P430HVN05.1EC

P43 Series Design Change

- Description: P430HVN05.1 (97D43P15.101) Design change items

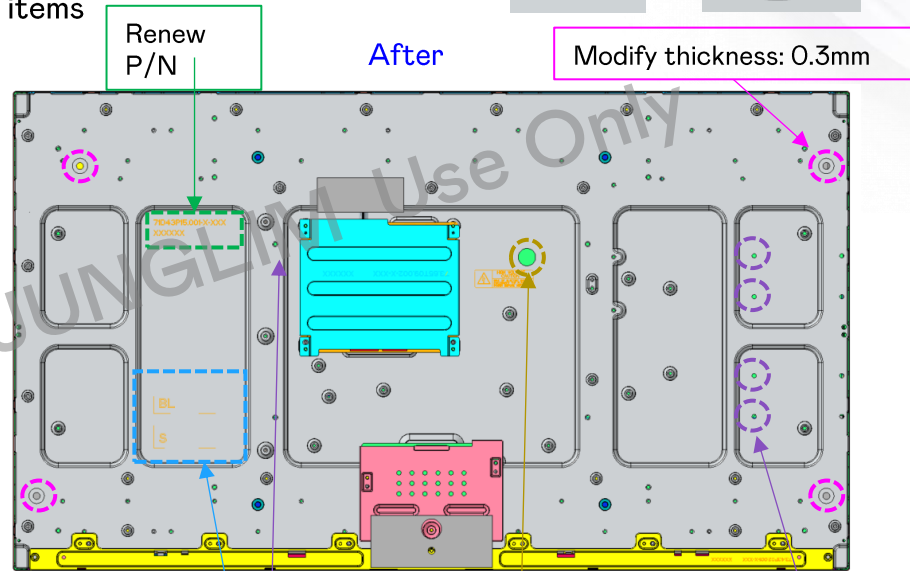
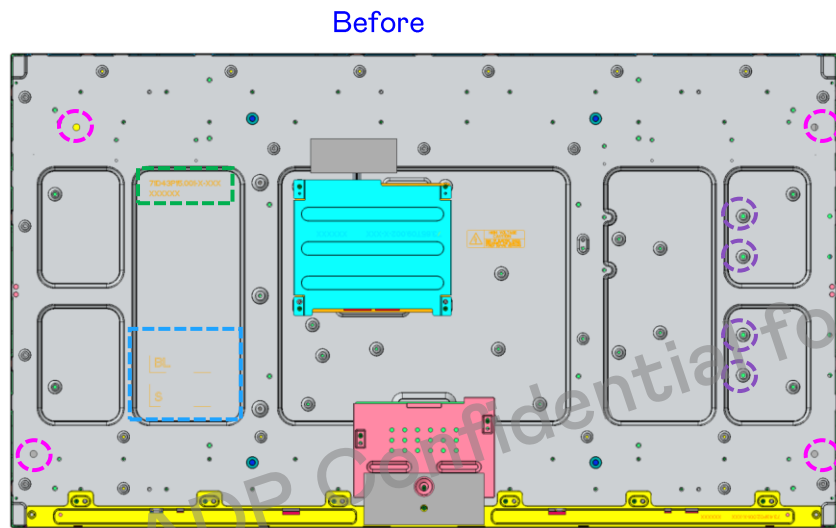
1. Remove the bottom protrusion
2. The position, total height, outer boundary, and screw holes of the rivet post are consistent with the original design.

P43 Series Design Change

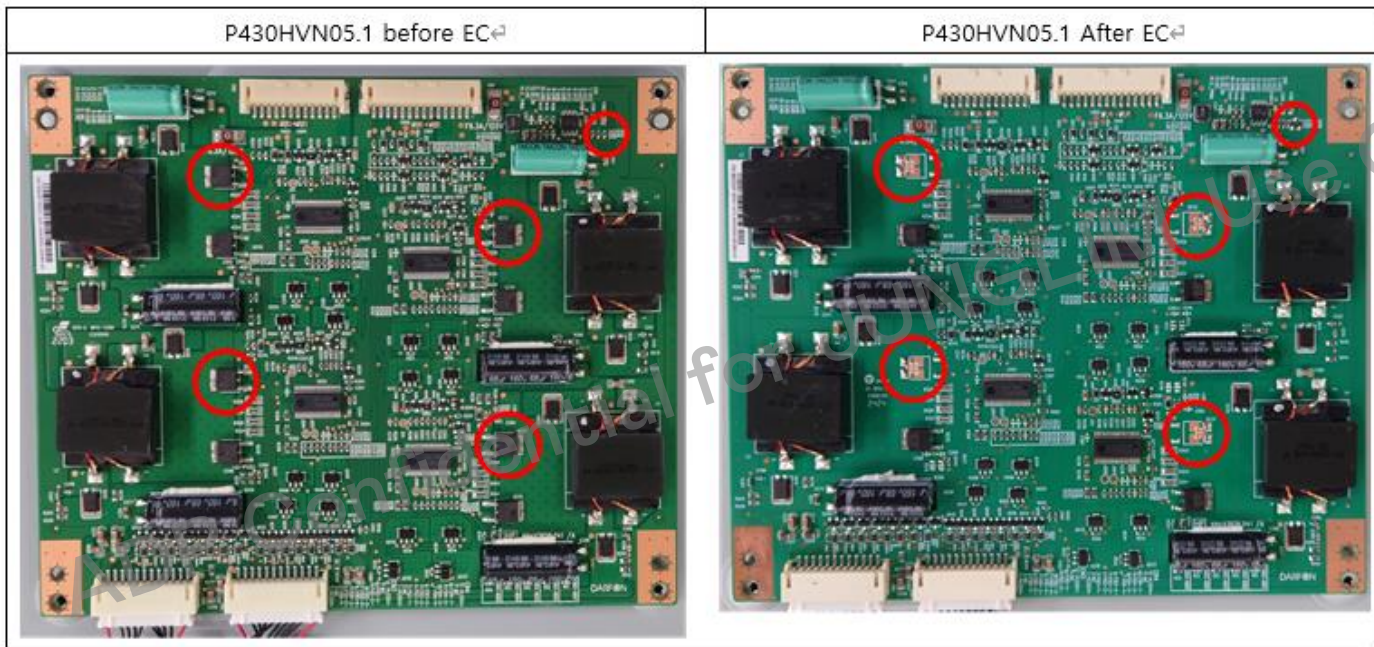
V100(Before EC)	V101(After EC)
DB Output Current	80mA	67mA
Power Consumption	134.9W	110W
Brightness	1500nits	1500nits
Output MOS	Output MOS: 2pcs * 4_DCDC	Output MOS: 1pcs * 4_DCDC
Q106	N/A	Add (reduce power consumption during standby mode)
